**TOWN OF MOUNTAIN VILLAGE
REGULAR DESIGN REVIEW BOARD MEETING
REVISED (2) AGENDA
THURSDAY JULY 1, 2021 10:00 AM
MOUNTAIN VILLAGE TOWN HALL
455 MOUNTAIN VILLAGE BLVD, MOUNTAIN VILLAGE, COLORADO
TO BE HELD IN PERSON / HYBRID ZOOM:**

**DESIGN REVIEW BOARD MEETING
AGENDA FOR JULY 1 , 2021**

AI.3

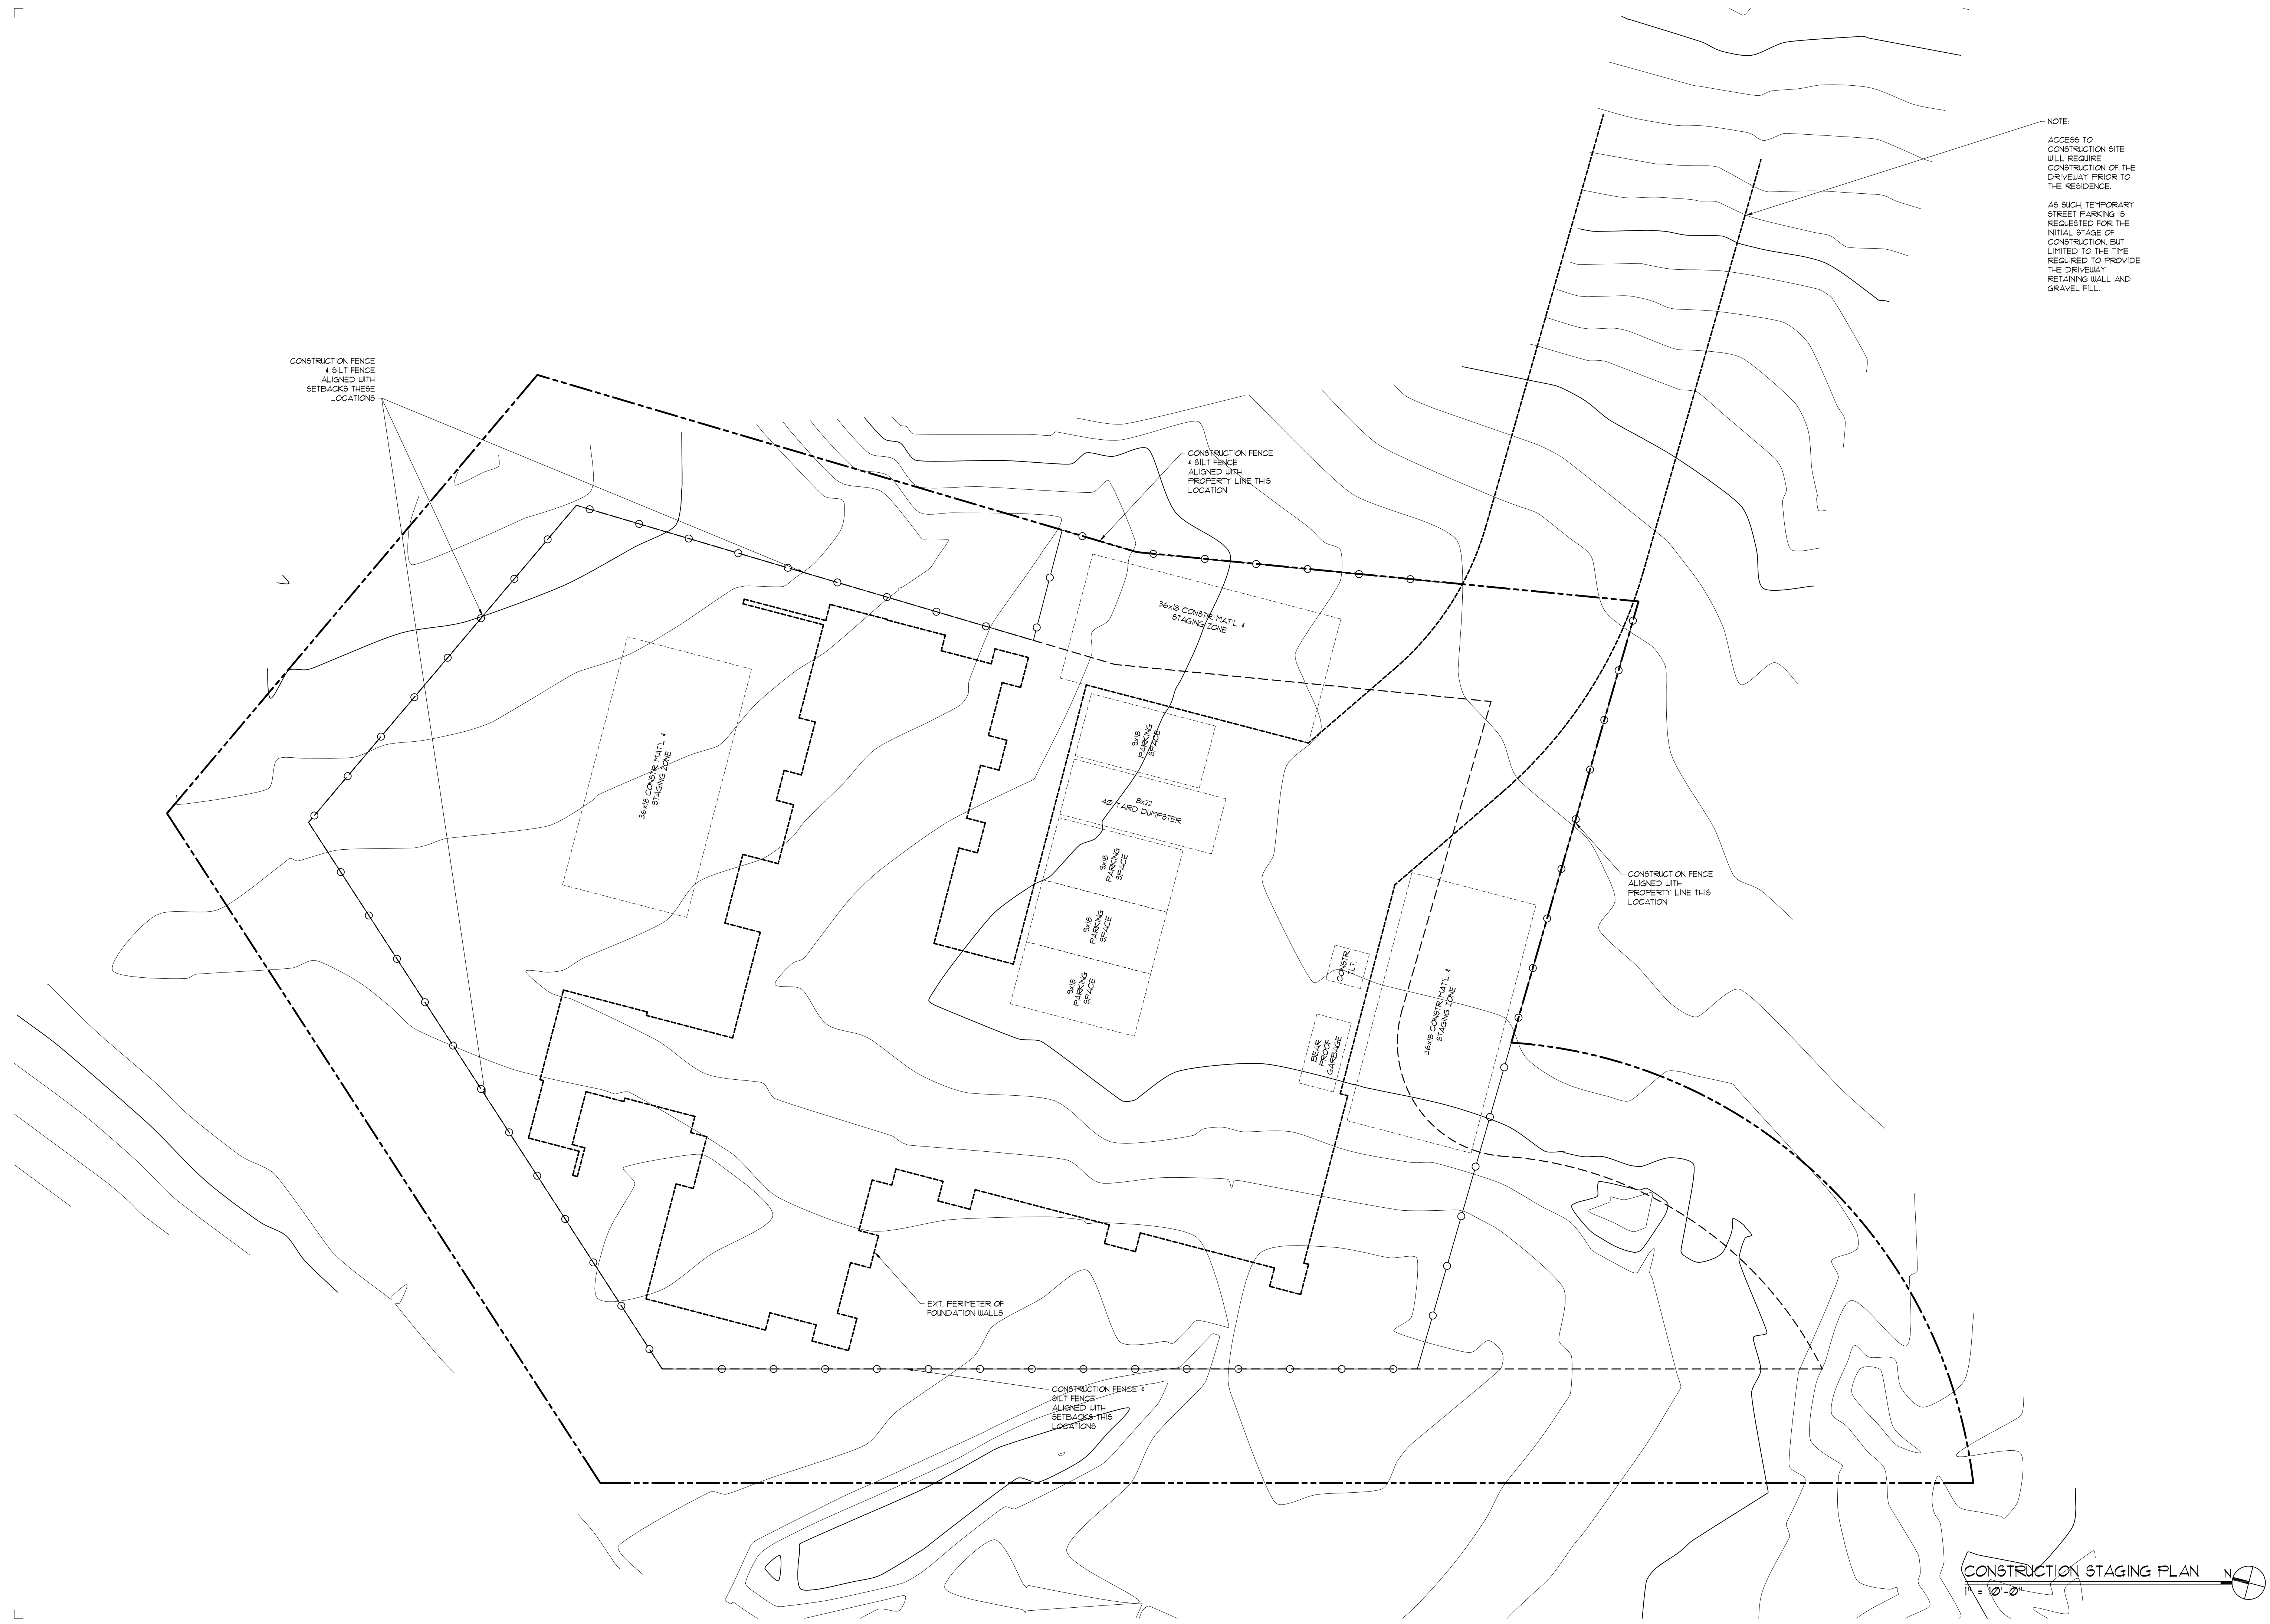
1. Due to the number of notes on the plan page A1.3, staff recommends separating the landscaping and fire mitigation plans into two separate documents – **revised**.

Utilities

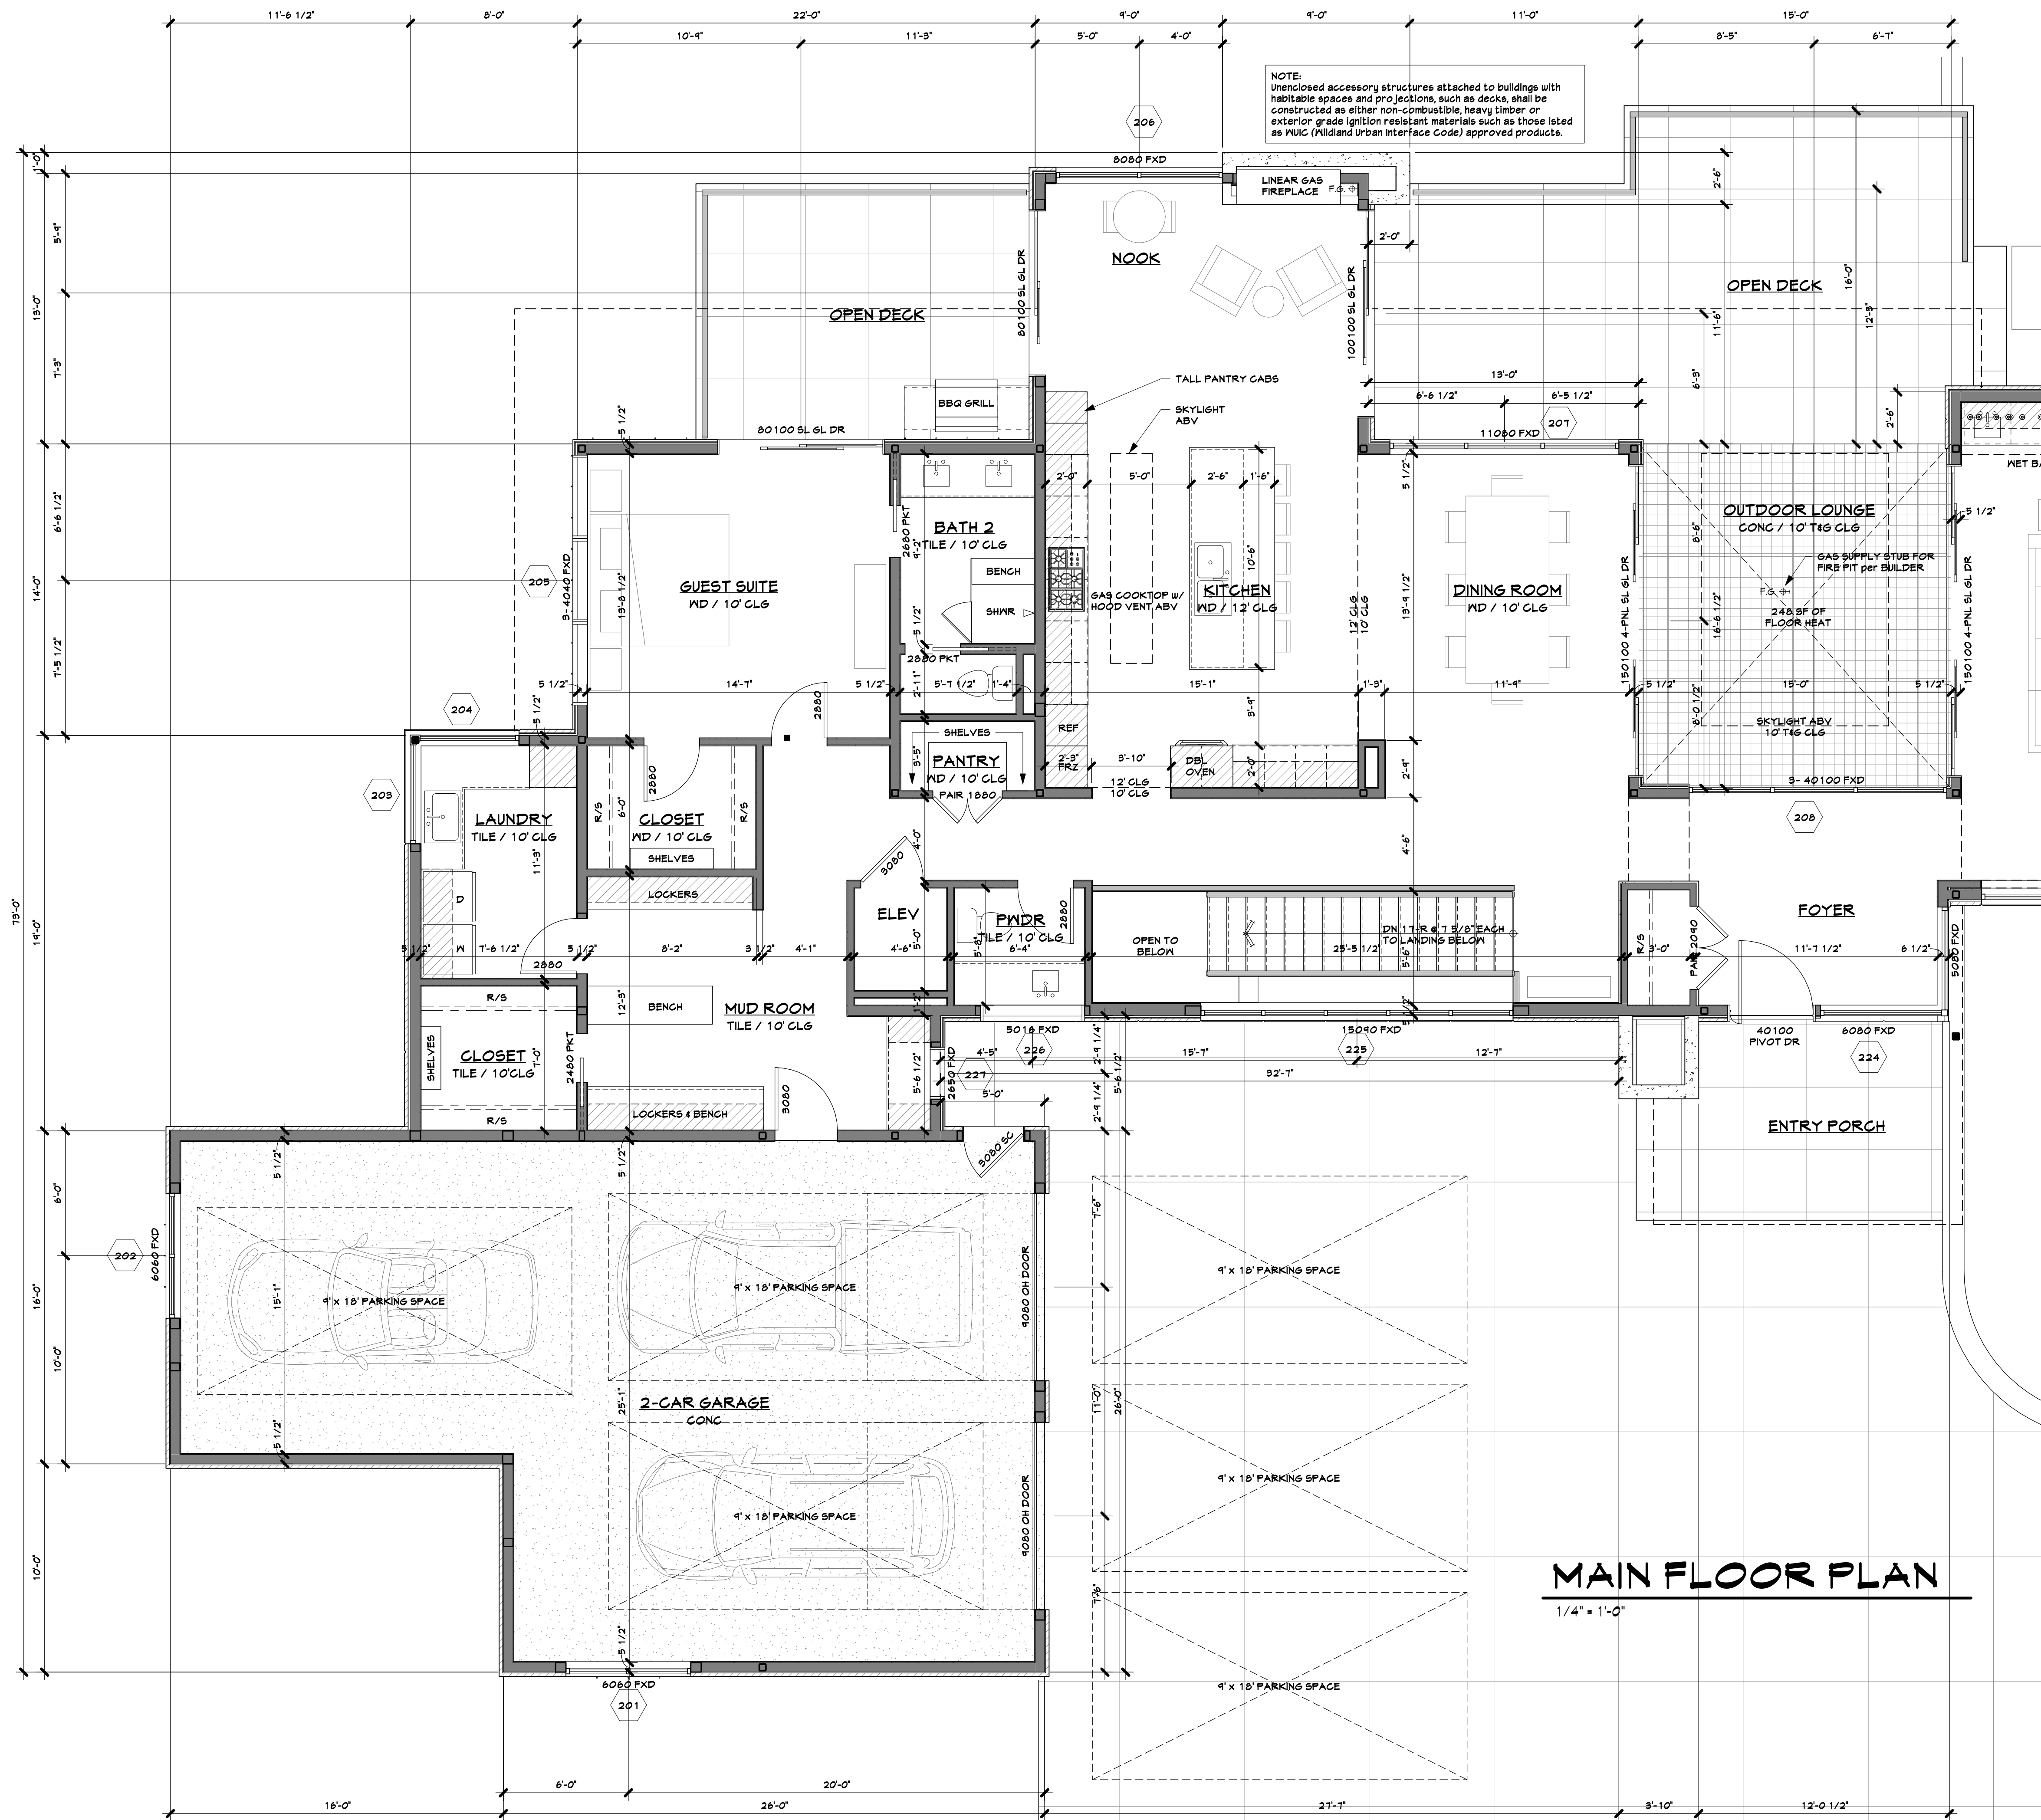
A condition of initial review was to detail snowmelt areas, and this has been updated for final – calling out 248 sq ft of snowmelt as shown on page A2.0.

1. Prior to the submittal for a Final Architectural Review, the applicant shall revise the plans to demonstrate all exterior snowmelt areas.
There is only one exterior snowmelt area at the "Outdoor Lounge" which contains 248 sf of radiant in-floor heat. This can be seen on sheet A2.0
